STATE OF ILLINOIS  
DEPARTMENT OF TRANSPORTATION

VARIOUS LOCATIONS  
SUMMARY OF QUANTITIES

F.A. RTE.	SECTION	COUNTY	TOTAL SHEETS	SHEET NO.
VAR.	2021-055-DR	VARIOUS	125	4
			CONTRACT NO. 62N86	
ILLINOIS FED. AID PROJECT

**175TH STREET – WESTERN AVE TO DIXMOOR DR  
TYPICAL SECTIONS**

STA 18+94 TO STA 37+00  
(LOOKING EAST)

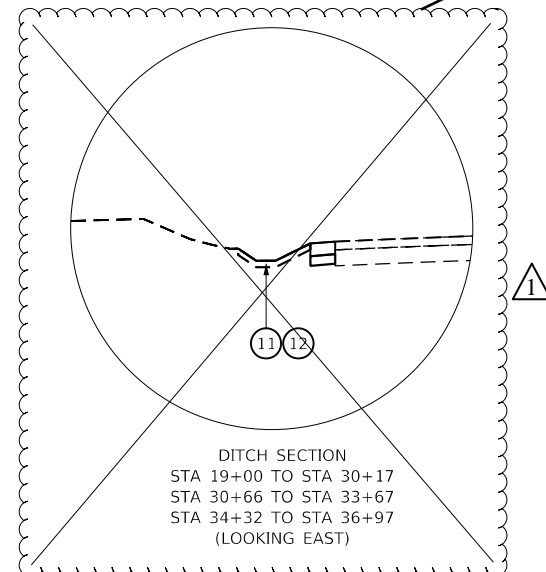
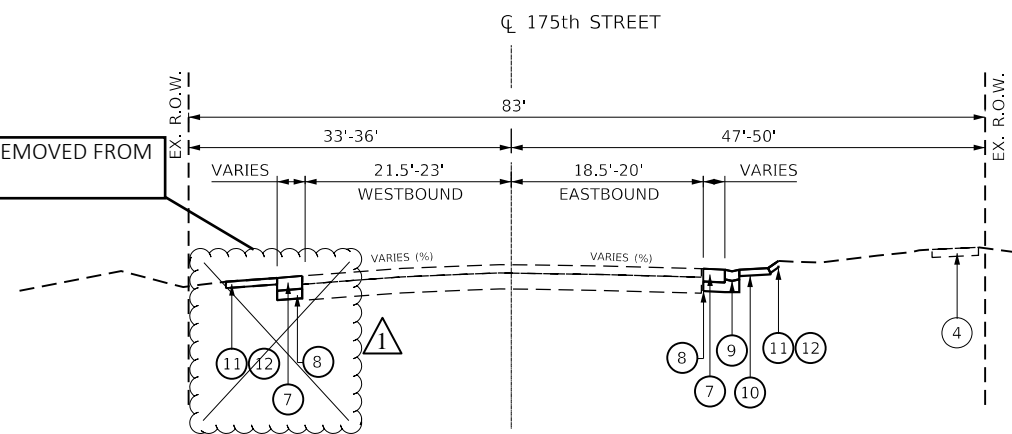
THIS WORK IS REMOVED FROM THE CONTRACT

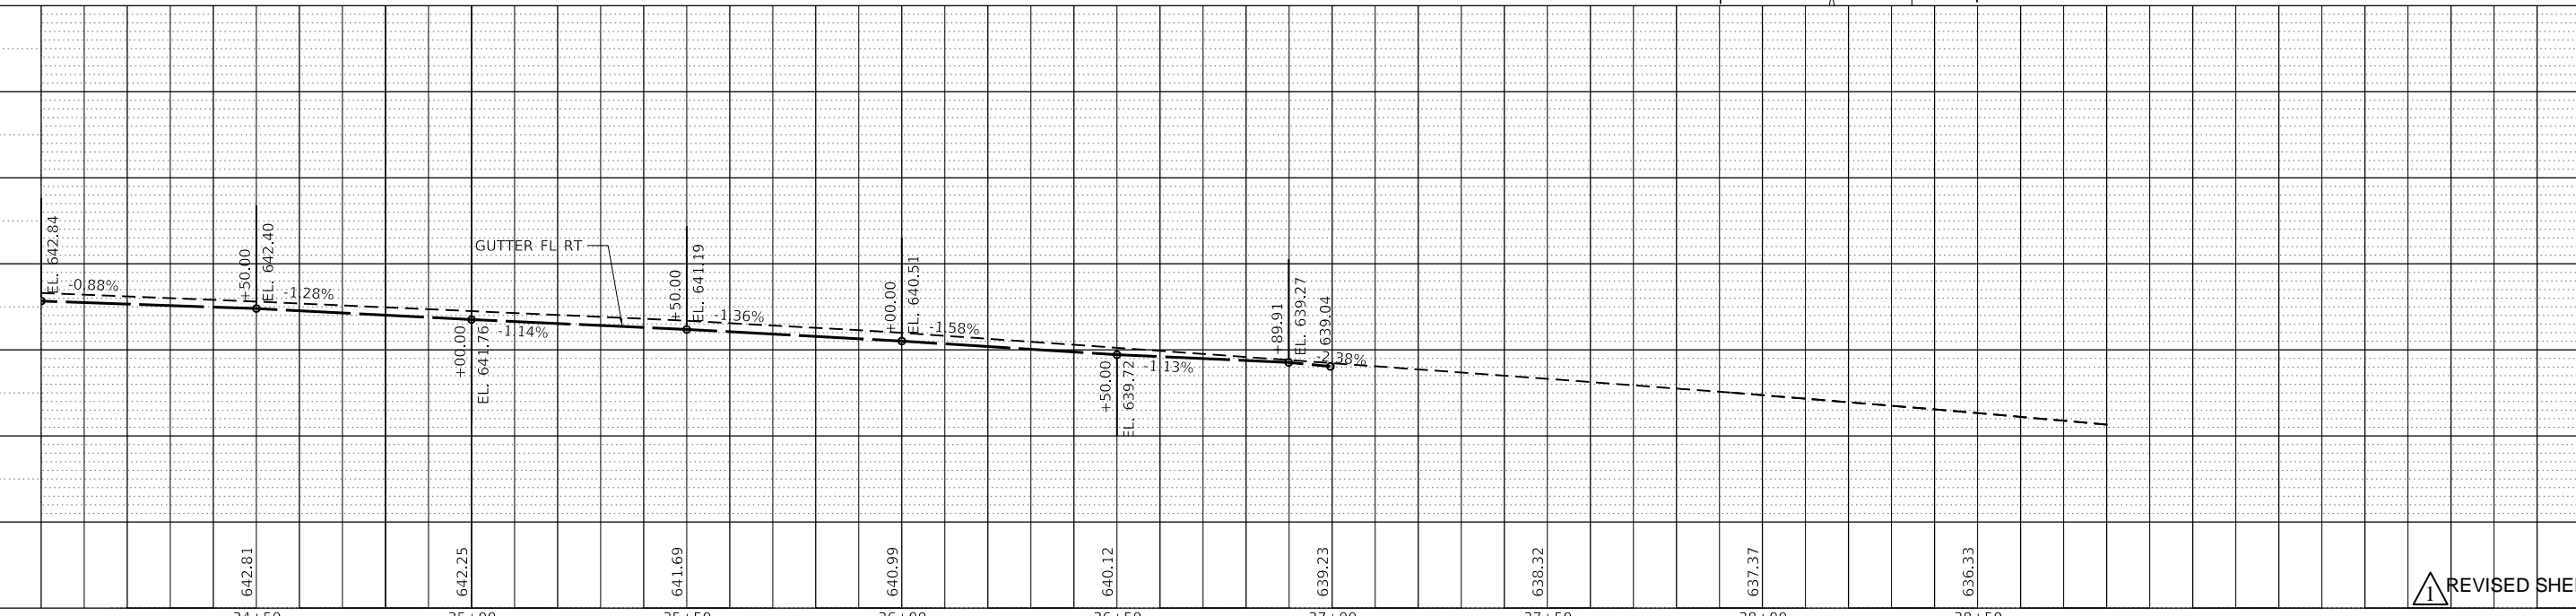
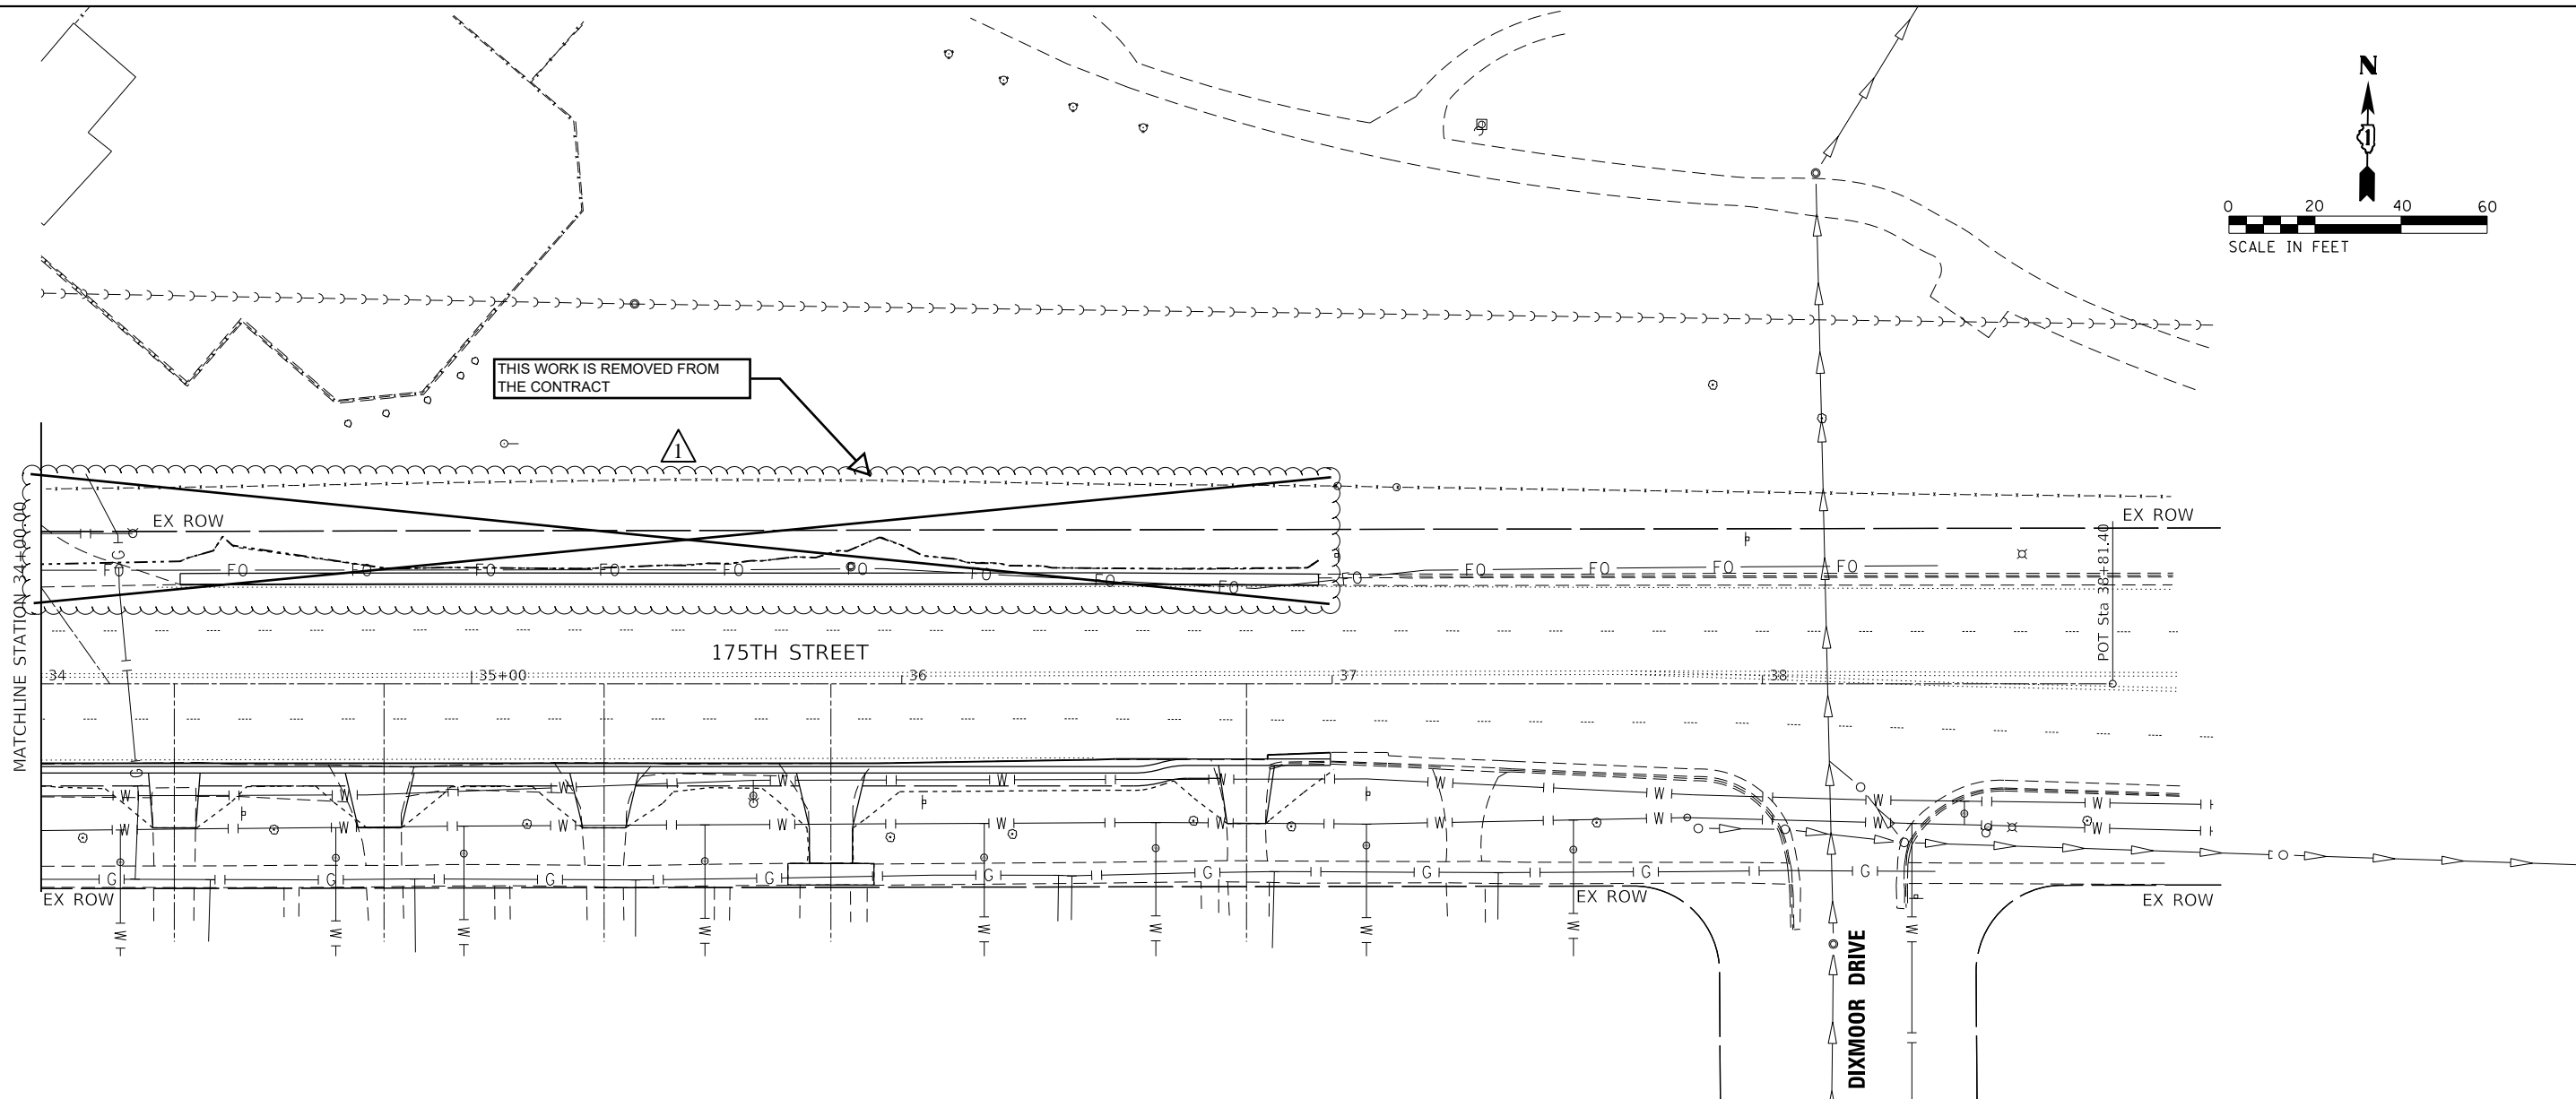
THIS WORK IS REMOVED FROM THE CONTRACT

THIS WORK IS REMOVED FROM THE CONTRACT

**175TH STREET CROSS SECTIONS**

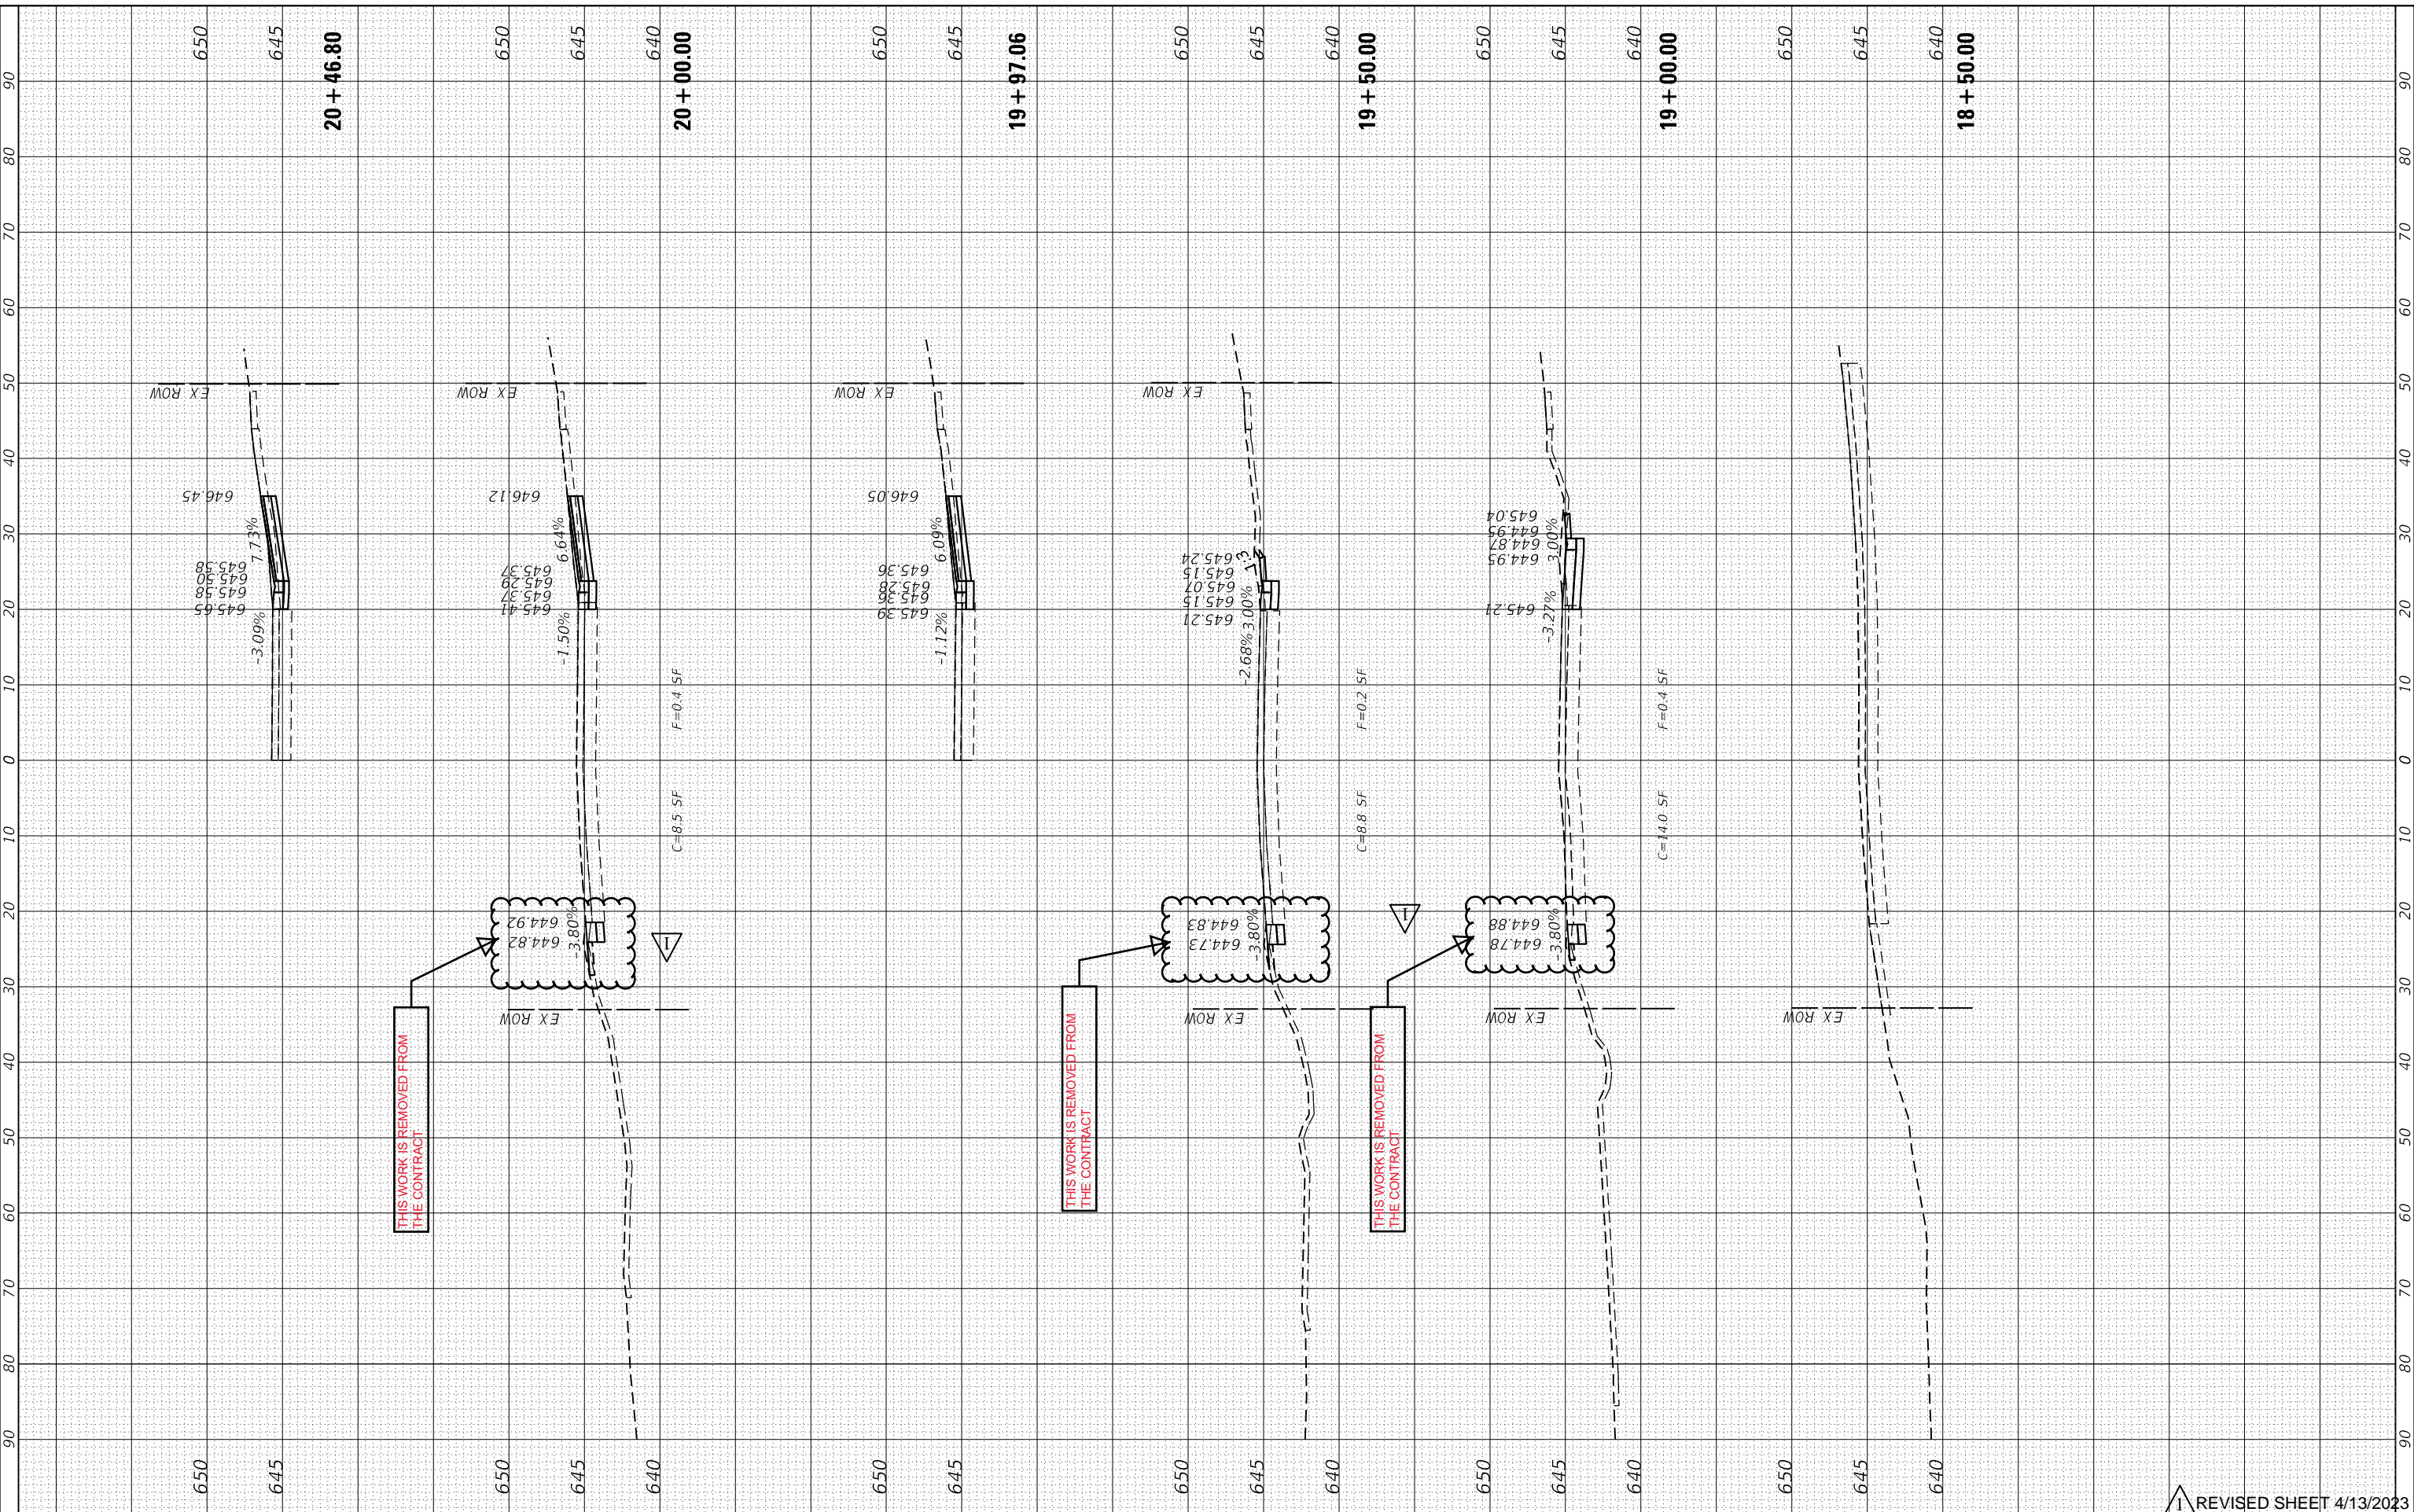
THIS WORK IS REMOVED FROM THE CONTRACT

THIS WORK IS REMOVED FROM THE CONTRACT

THIS WORK IS REMOVED FROM THE CONTRACT
